## ST. TAMMANY PARISH

**Addendum No.:** 2

**Bid#:** 24-47-2

**Project Name:** River Oaks Building & Well Improvements

**STAIR PLAN**  
SCALE: 1/2" = 1'-0"

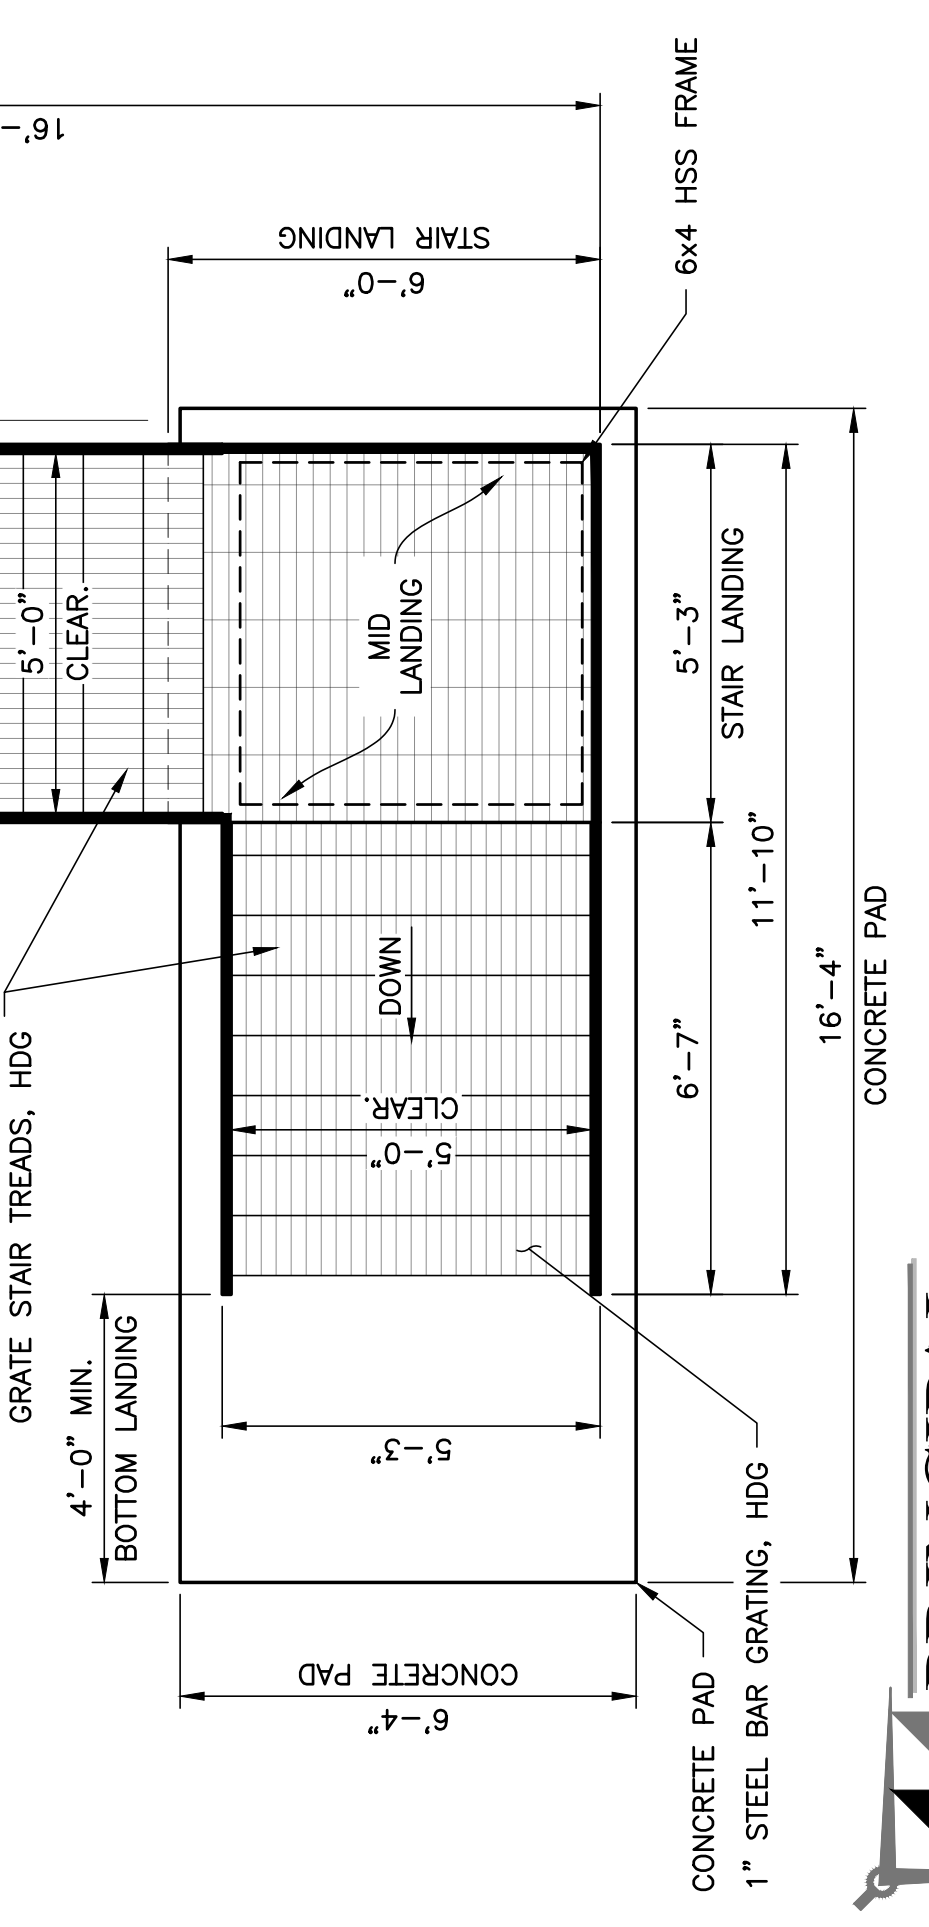
No.	DESCRIPTION OF REVISION	DATE
2	ADJUSTED ELEVATION OF WELL ACCESS STAIR	11.19.24

RIVER OAKS  
BUILDING & WELL IMPROVEMENTS  
PROJECT No.: TU23000160  
WATER WELL DETAILS

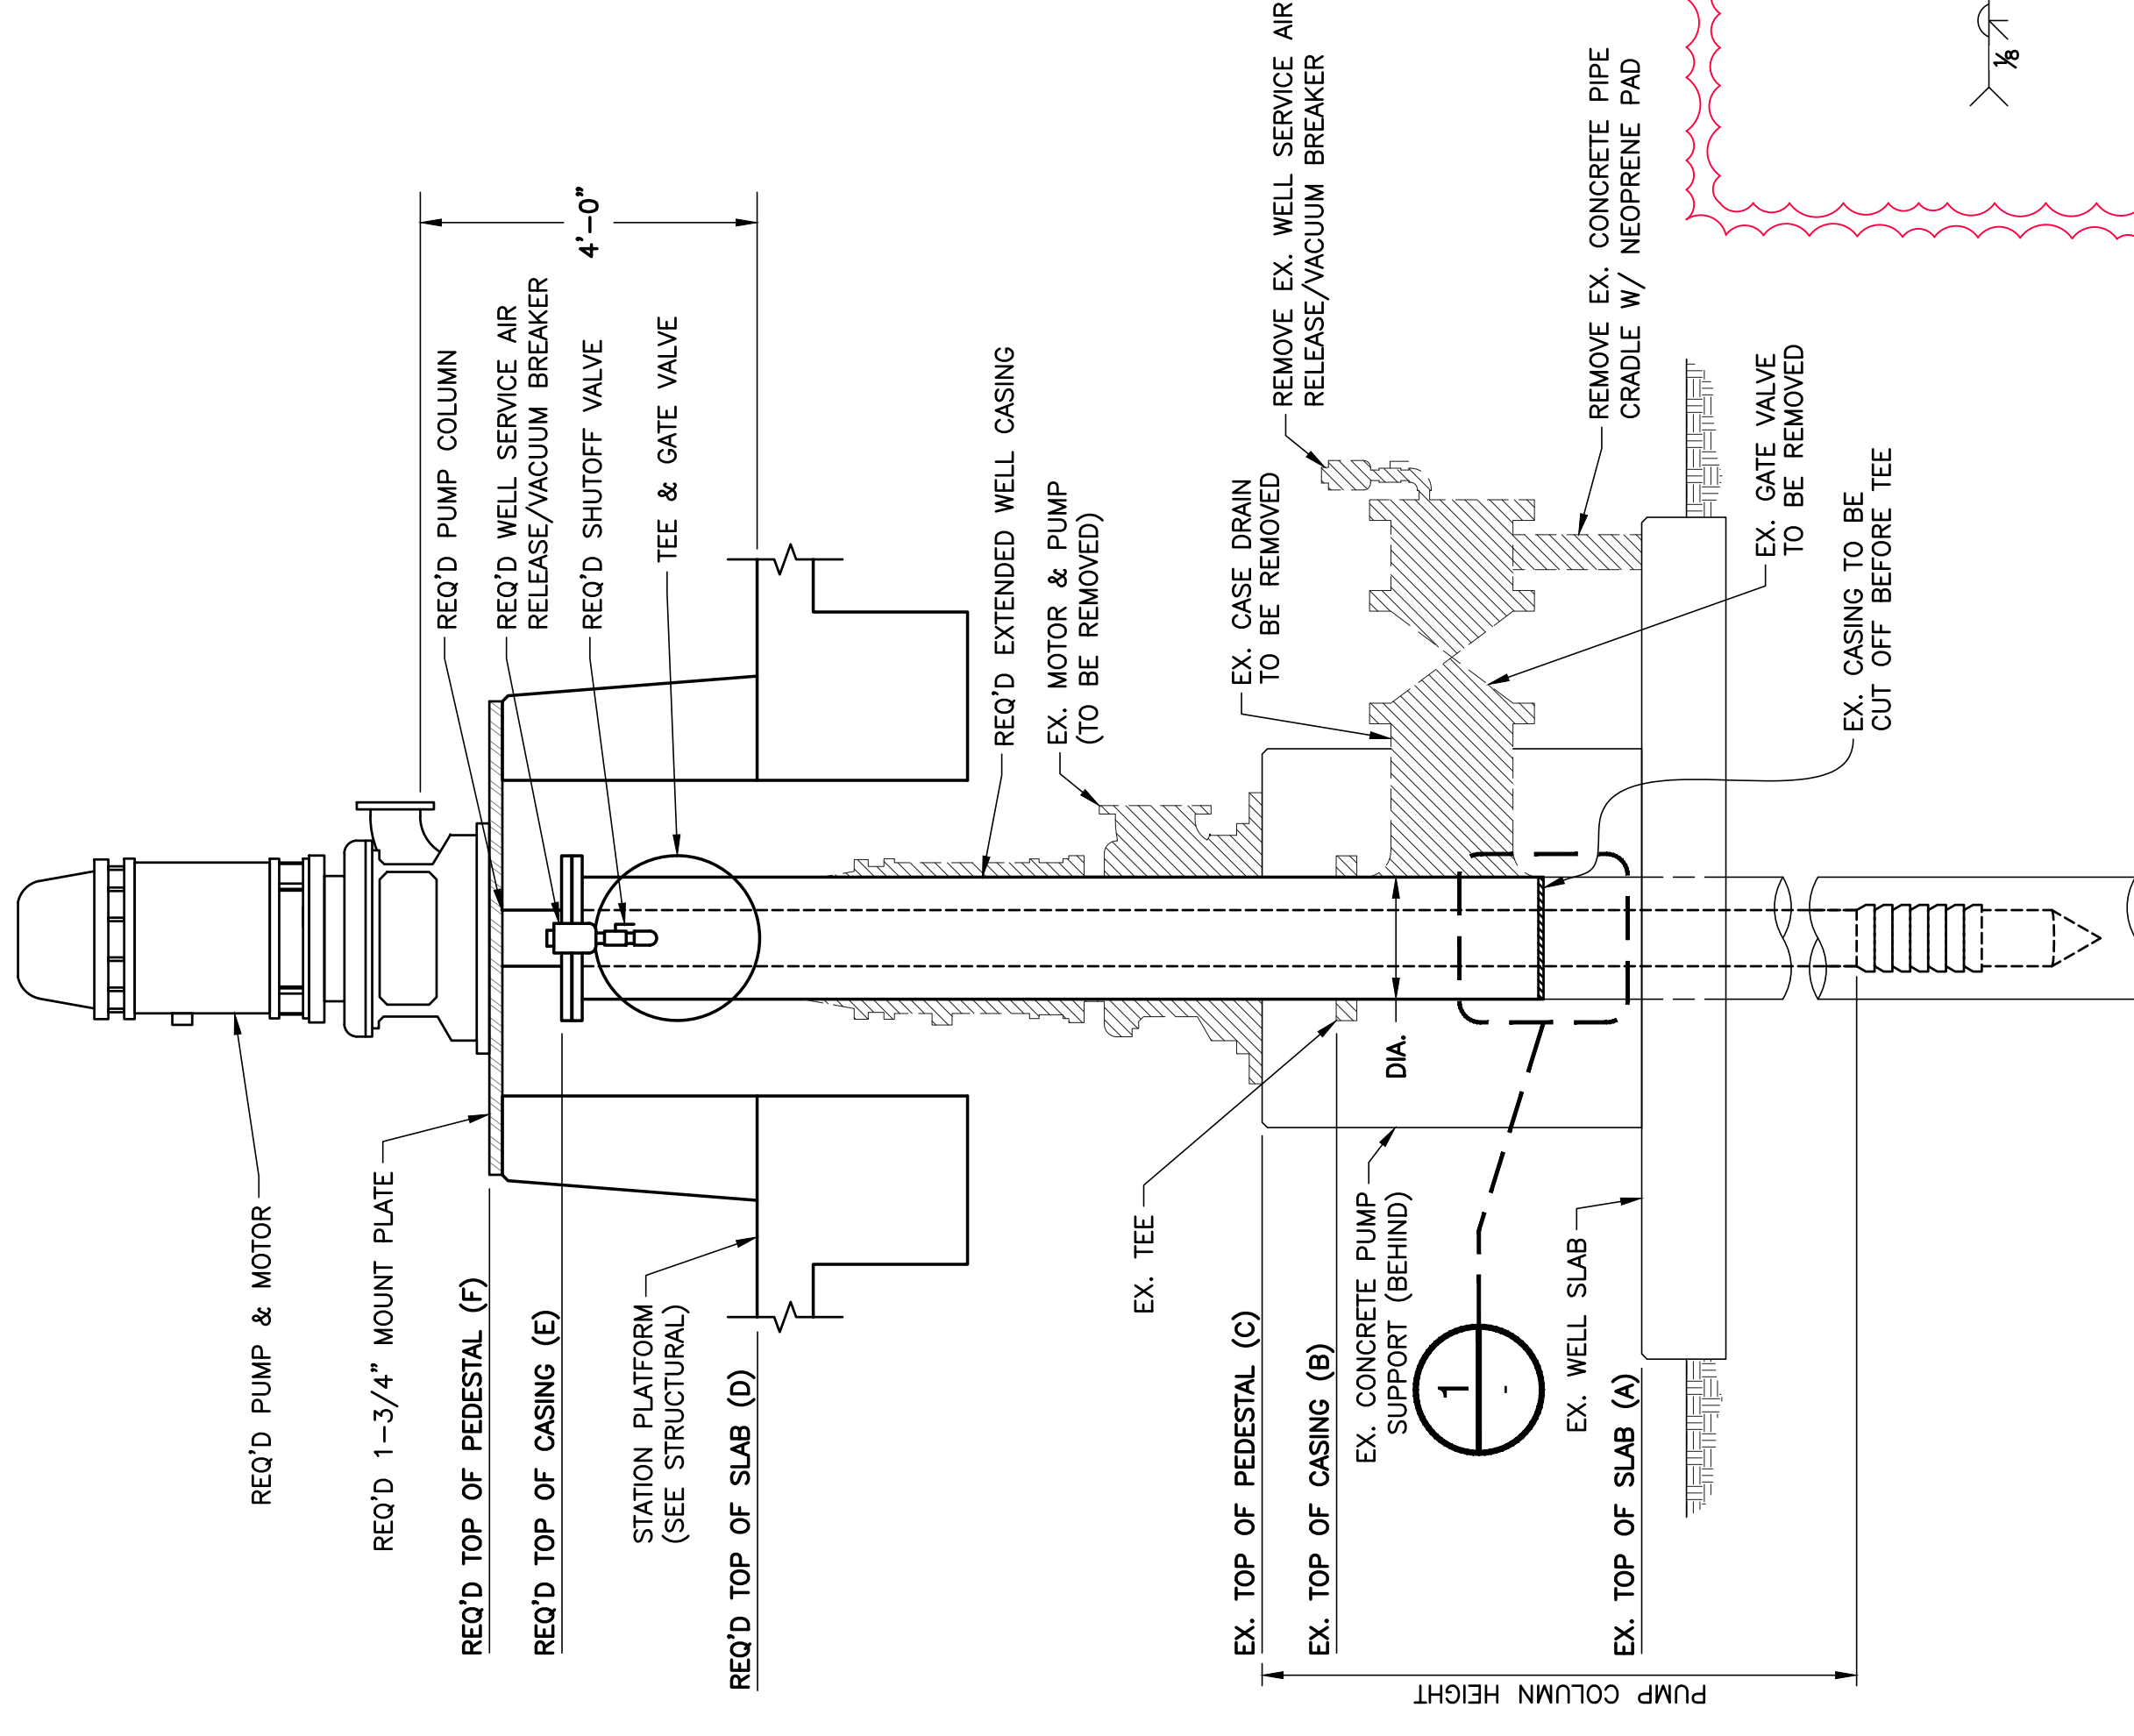
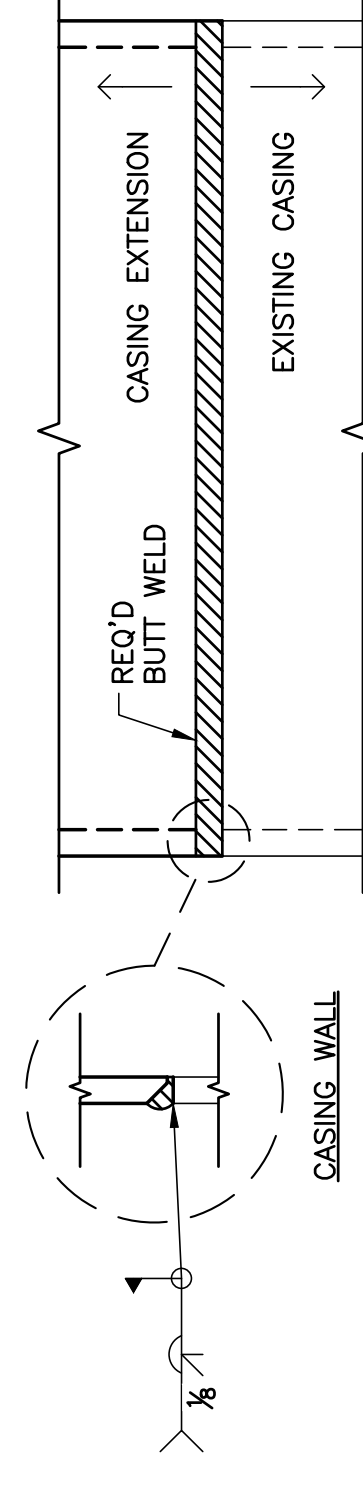
10. Drawings Sheet # 25 Water Well Details shows extending the well and installing a new pump etc....
  - a. Specification Section 02525 Water Wells.
  - b. Questions: Since this is an existing well, Is a Test Well Required? *Answer: No.*

- i. Well Pump Test required? *Answer: An operational pump and well test will be required. Refer to Plan Sheet for additional information.*
    - ii. Specification reference Well Driller? We are not drilling a well. *Answer: Correct*

- iii. Specification reference a Structural Integrity of the well is responsibility of the Contractor. This is an existing well.
    - iv. Could you please clarify what will be required. *Answer: Structural integrity is in reference to the well extension, not the existing well.*

No.	DESCRIPTION OF REVISION	DATE
2	ADJUSTED ELEVATION OF WELL PEDESTAL	11.19.24
	ADJUSTED WELLHEAD DATA ELEVATIONS	
	ADDED WELL HEAD WELD DETAIL.

Topographic Survey of  
**PARCEL A**  
**RIVER OAKS SUBDIVISION**  
**ADDITION NO. NINE**  
**ST. TAMMANY PARISH, LOUISIANA**

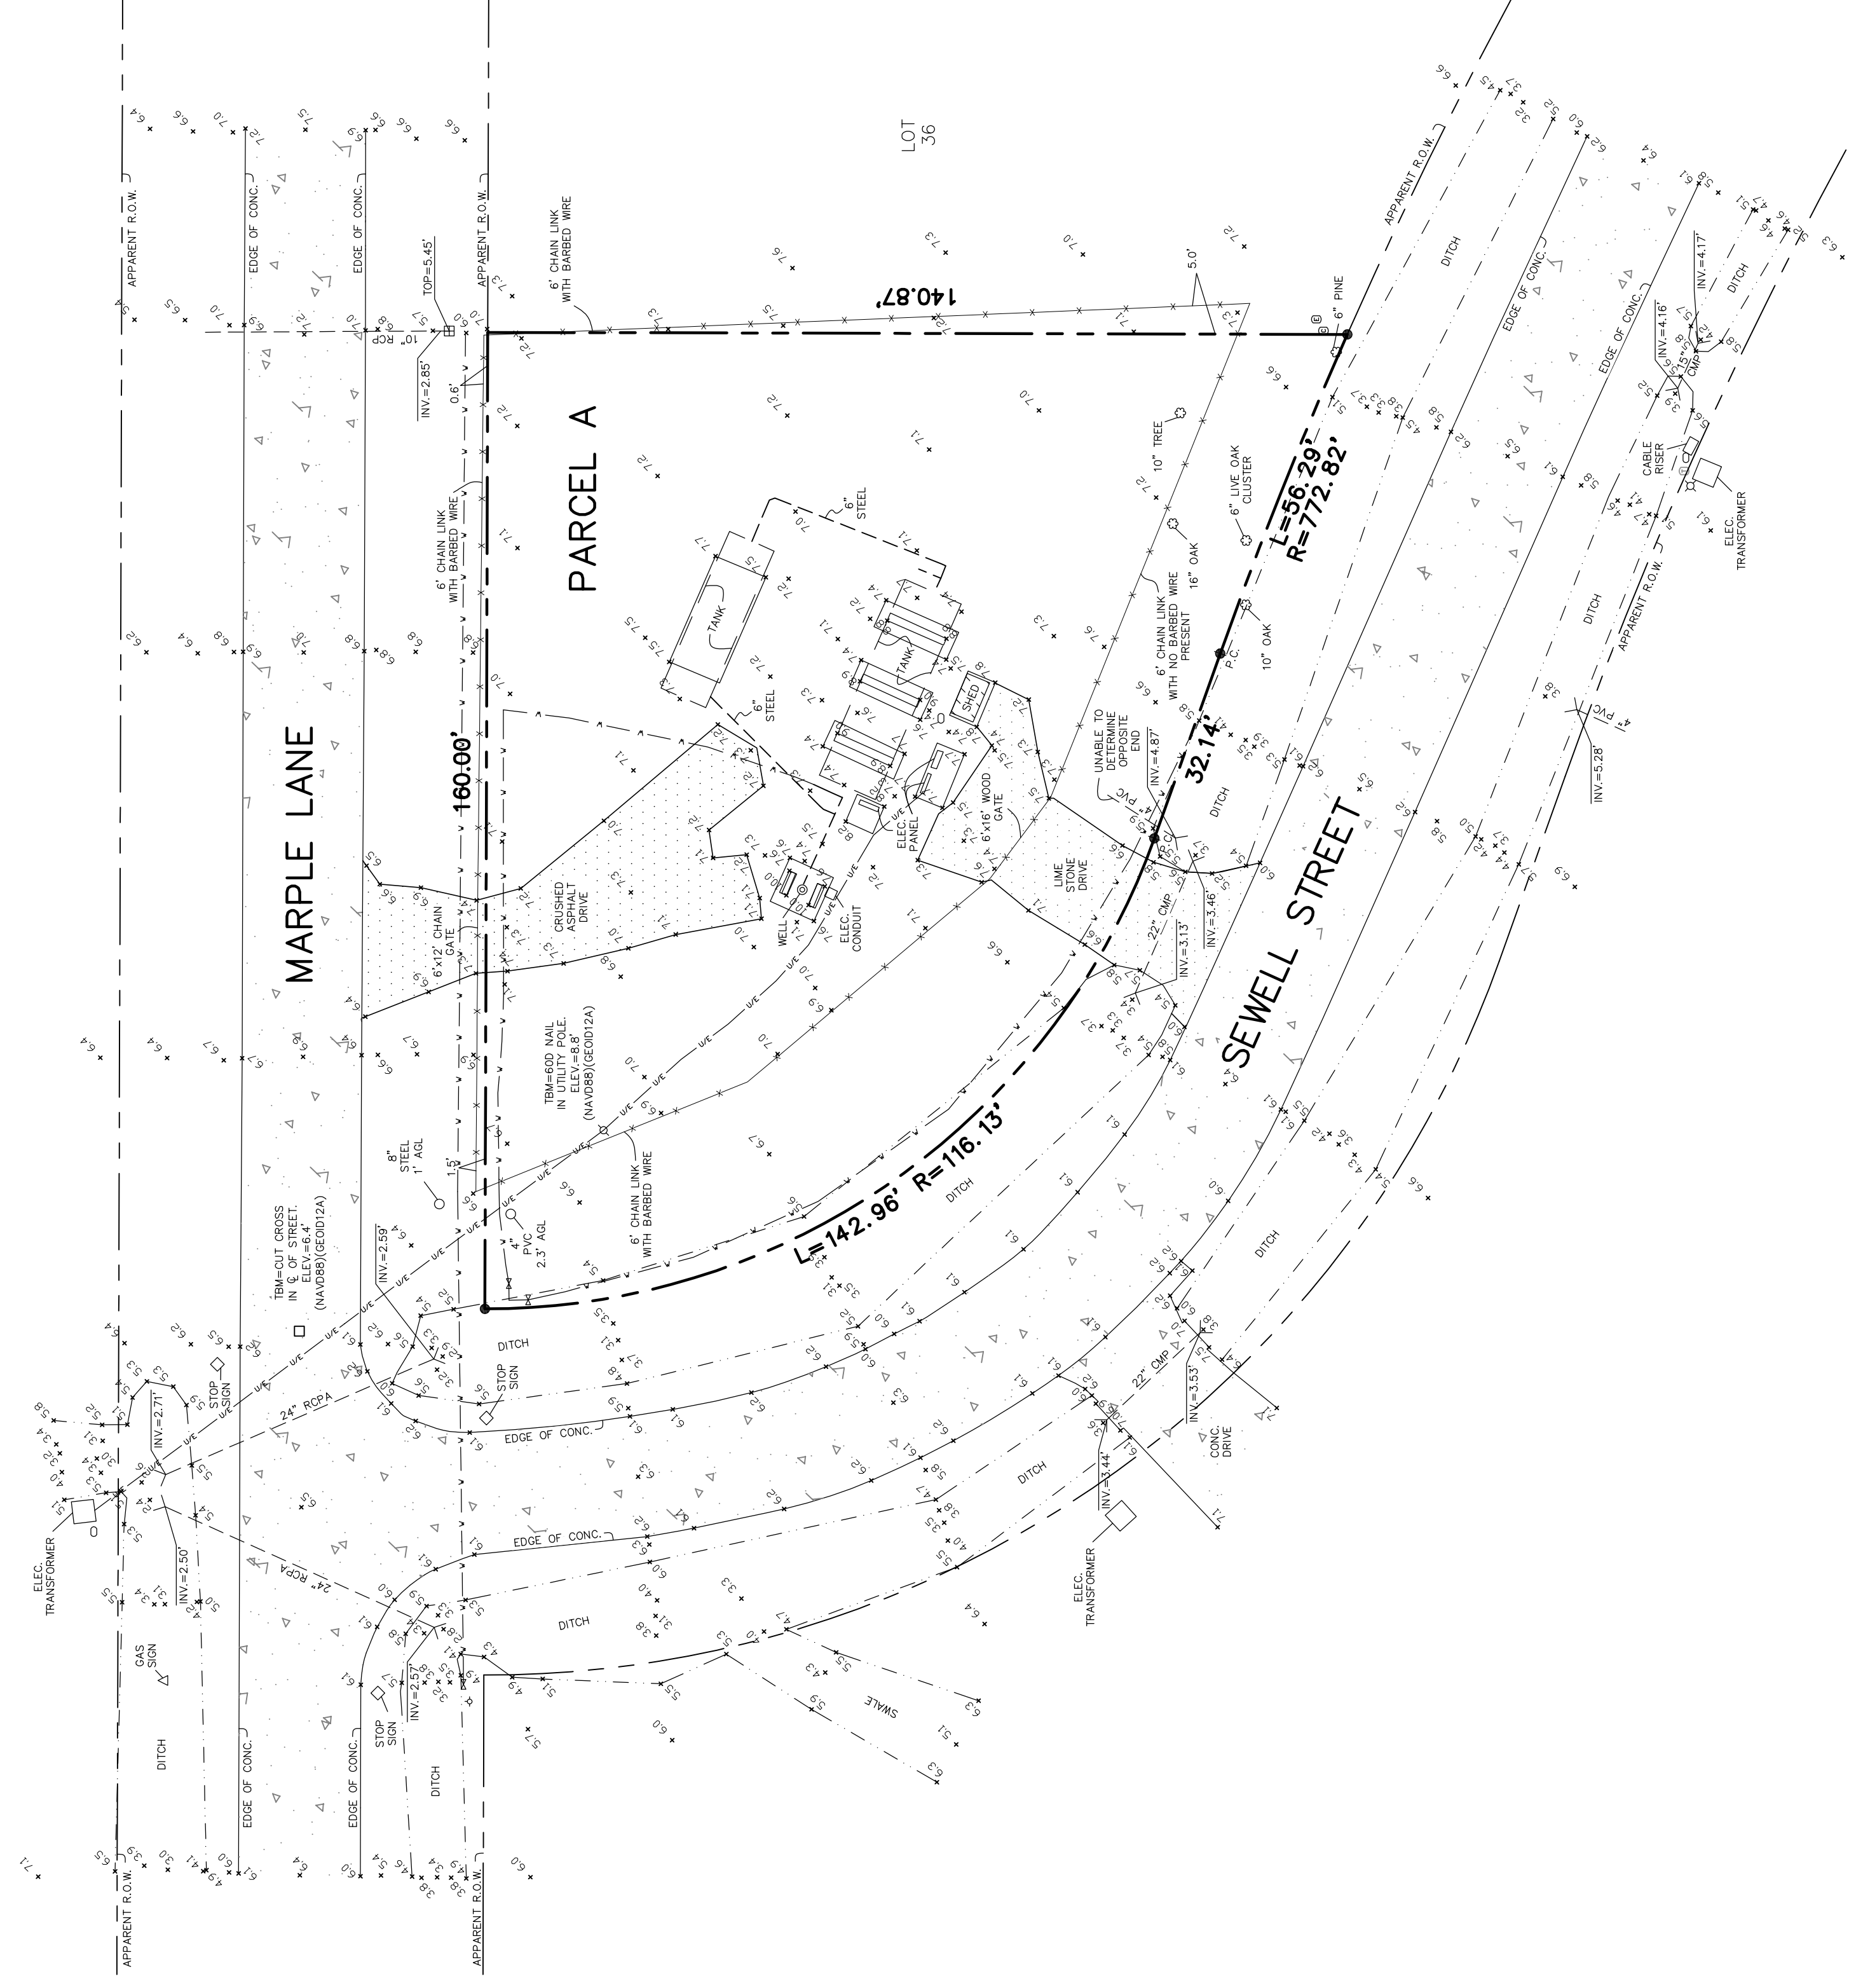
1. Question: Can you please provide the flood elevation certificate? This is needed to make sure well pump/etc. is mounted at the correct height. *Answer: Attached is the Topographic*

*Survey for the River Oaks site. The notation on the survey indicates that the property is in Flood Zone A10, BFE=9'. The new, preliminary maps indicate that the property is in Flood Zone AE, with BFE=14'. Elevations of the elevated deck and the pump/motor have been set based on the new, higher elevations.*
